MULTISITE ROOFING 2015 - C.I.P. #450.780.209
Edison Elementary School, Willaplespie Elementary School, and Education Center

ADDENDUM 1

EDISON ELEMENTARY
SCHOOL ROOF PLANS

EDISON ELEMENTARY
SCHOOL ROOF DETAILS
ALTERNATE NO. 1

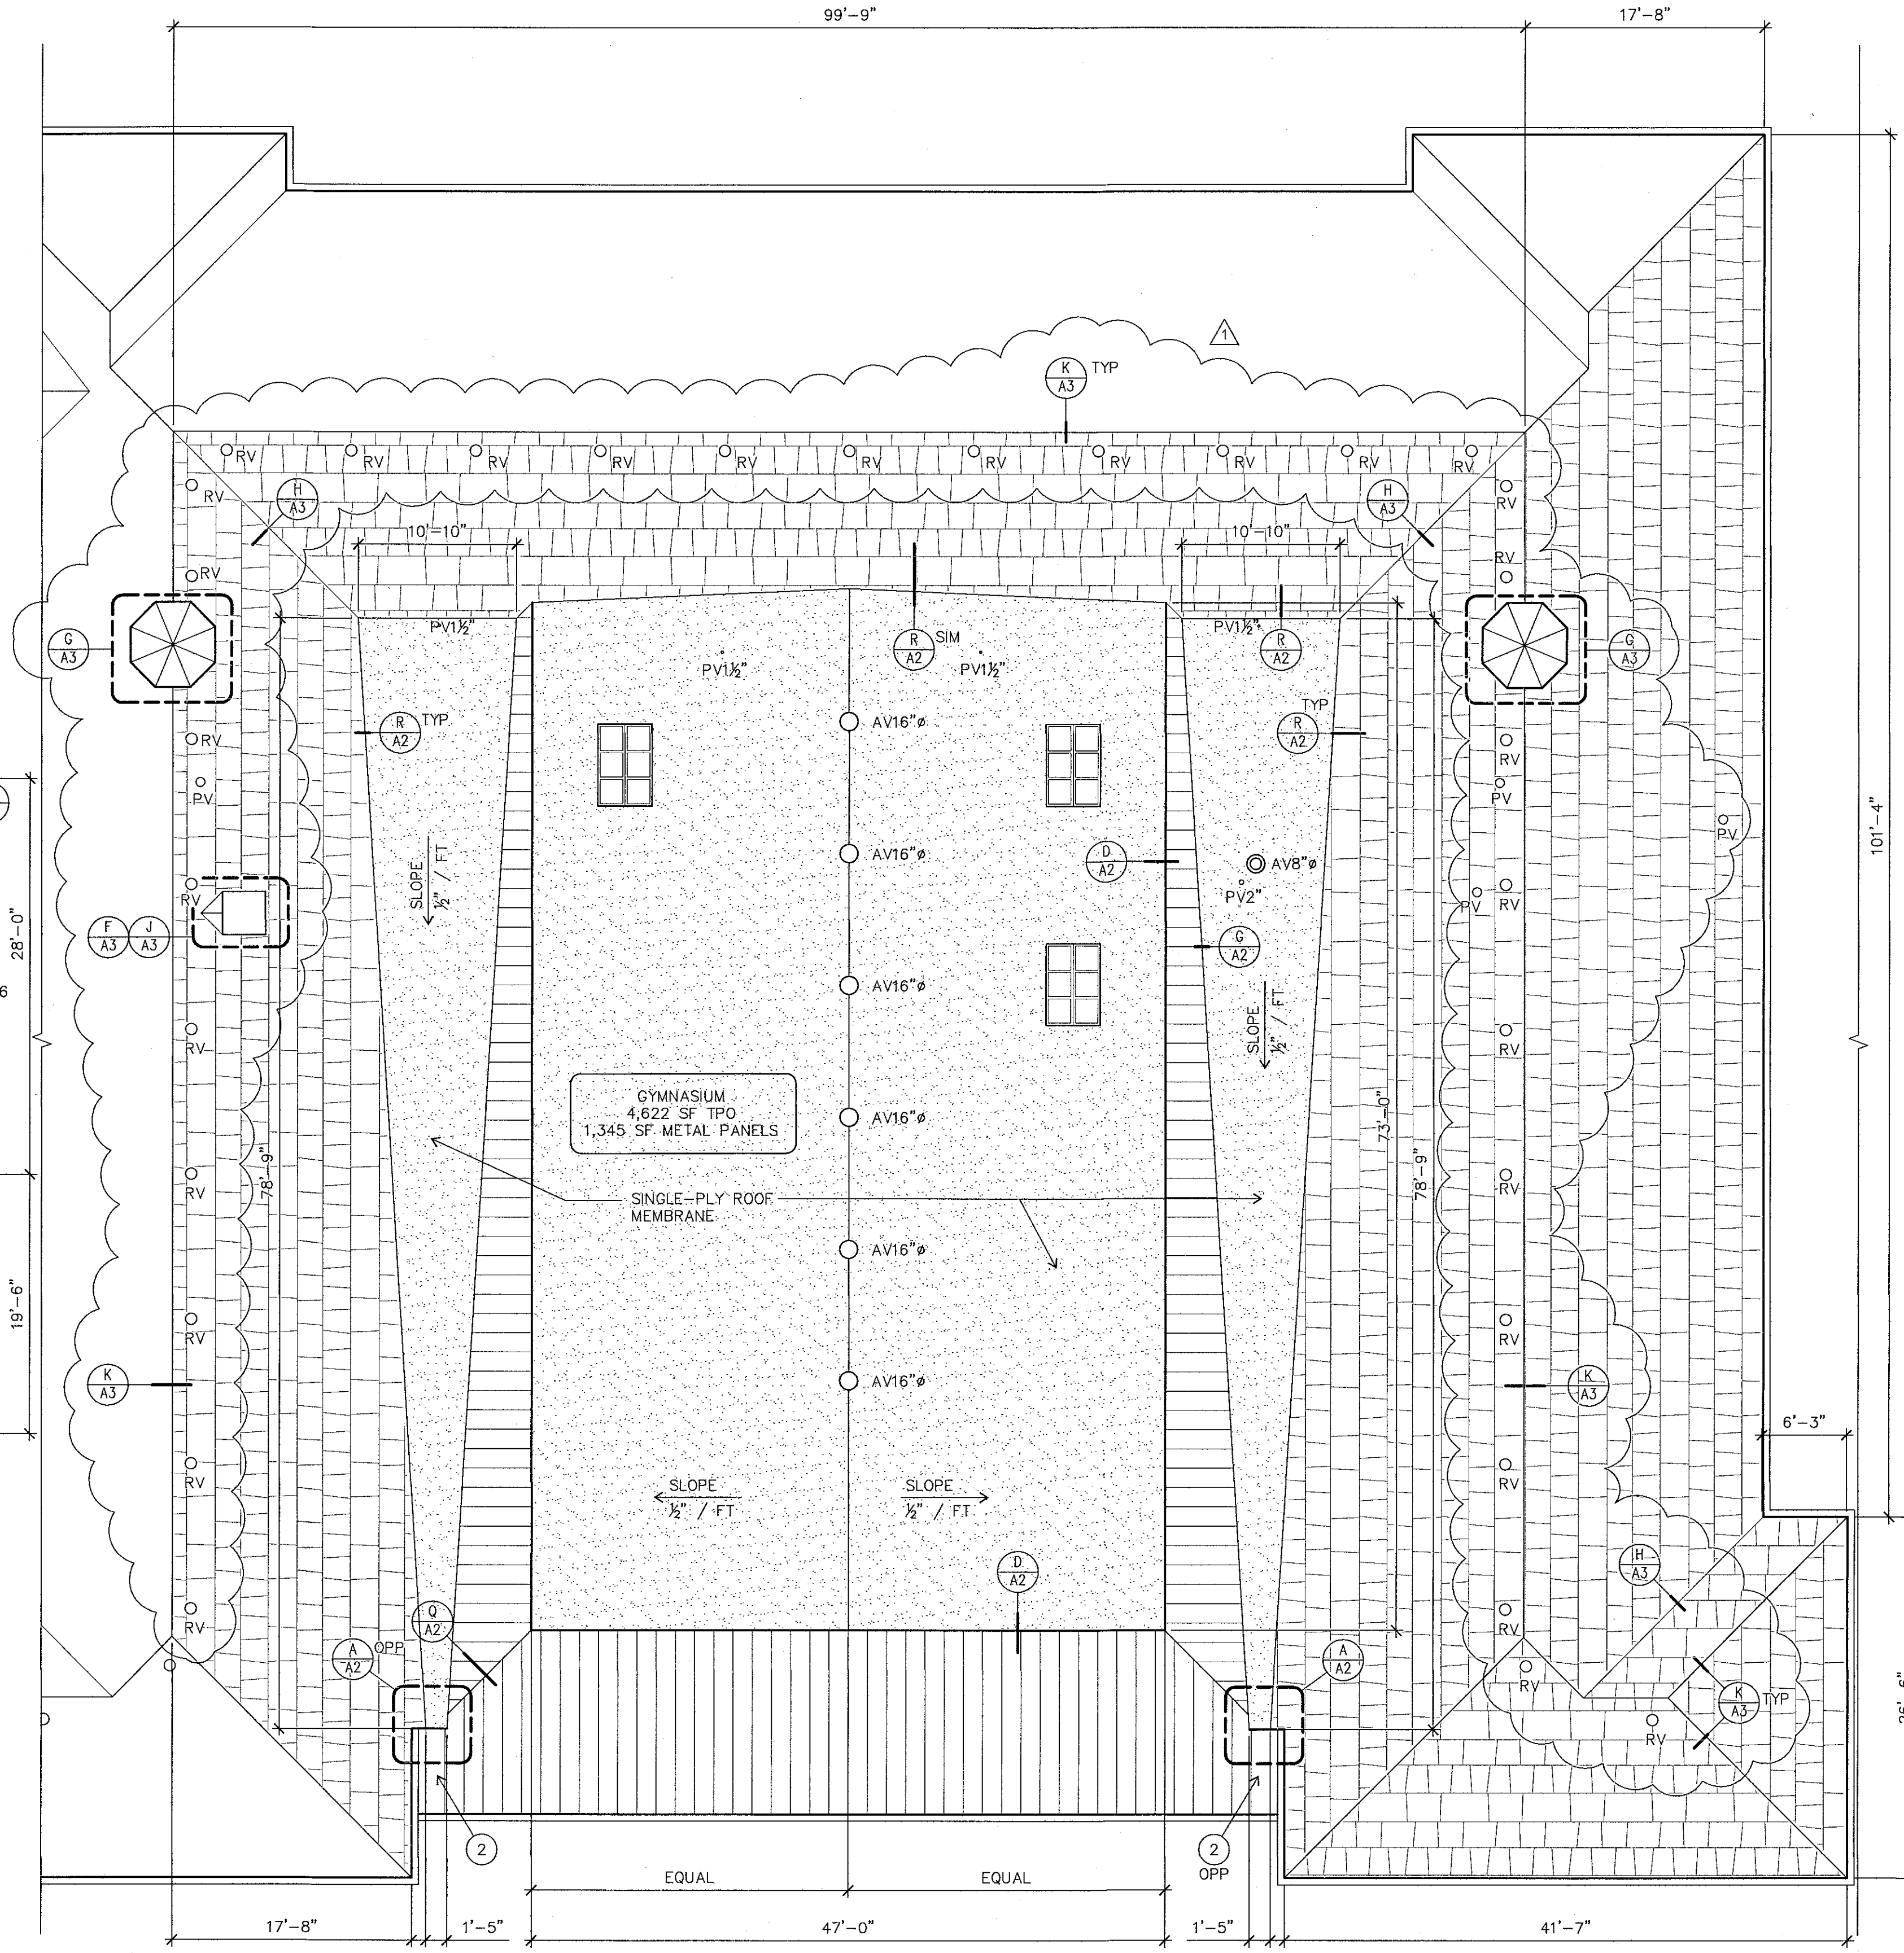
- 1 PROVIDE NEW GUTTER AT KITCHEN ROOF
- 2 SEE E/A3 FOR WATERWAY UNDER ALTERNATE NO. 1

K RIDGE
A3 N.T.S.

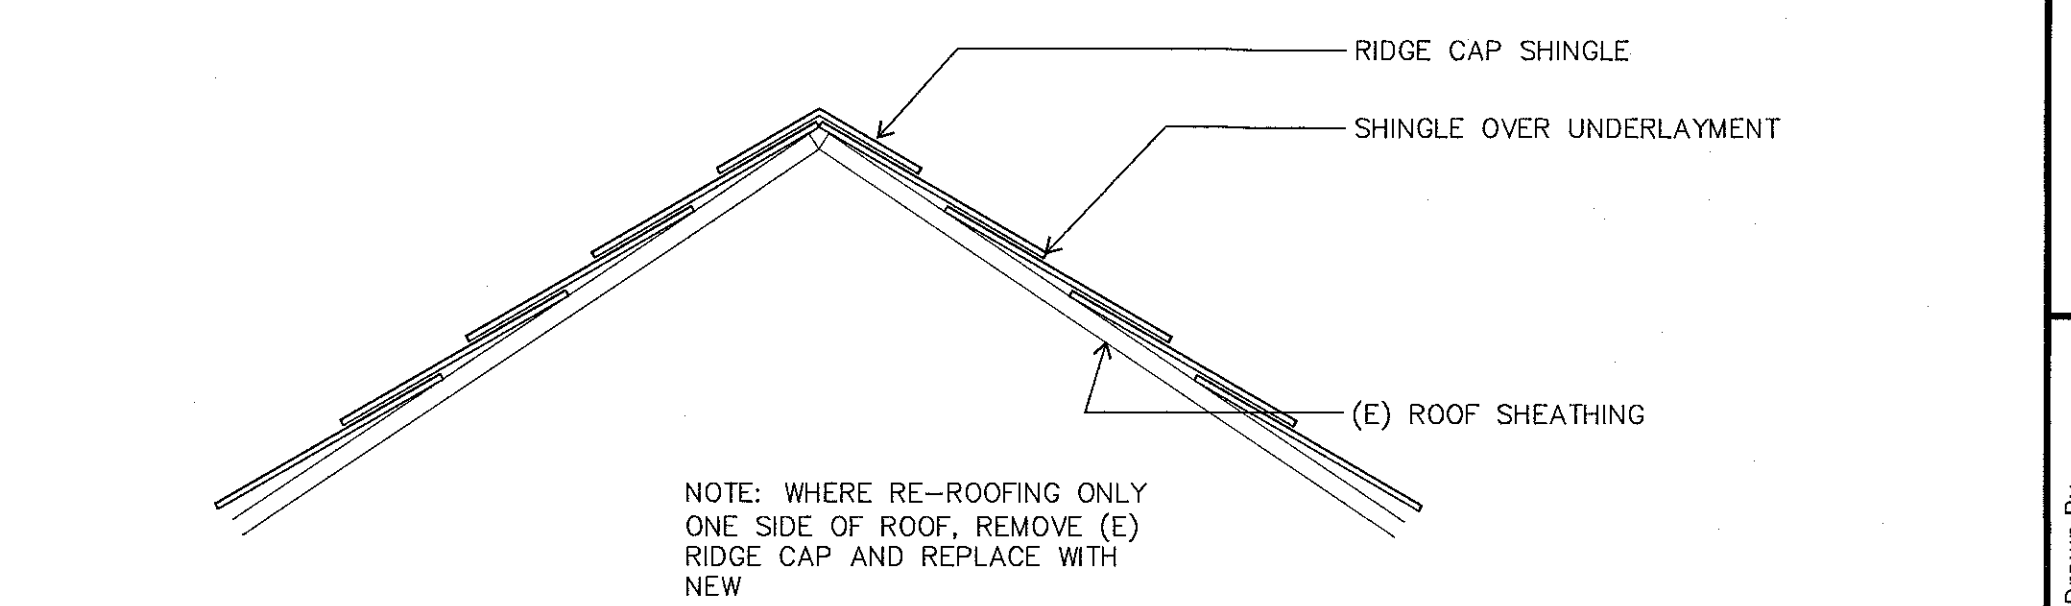
NOTE: WHERE RE-ROOFING ONLY ONE SIDE OF ROOF, REMOVE (E) RIDGE CAP AND REPLACE WITH NEW
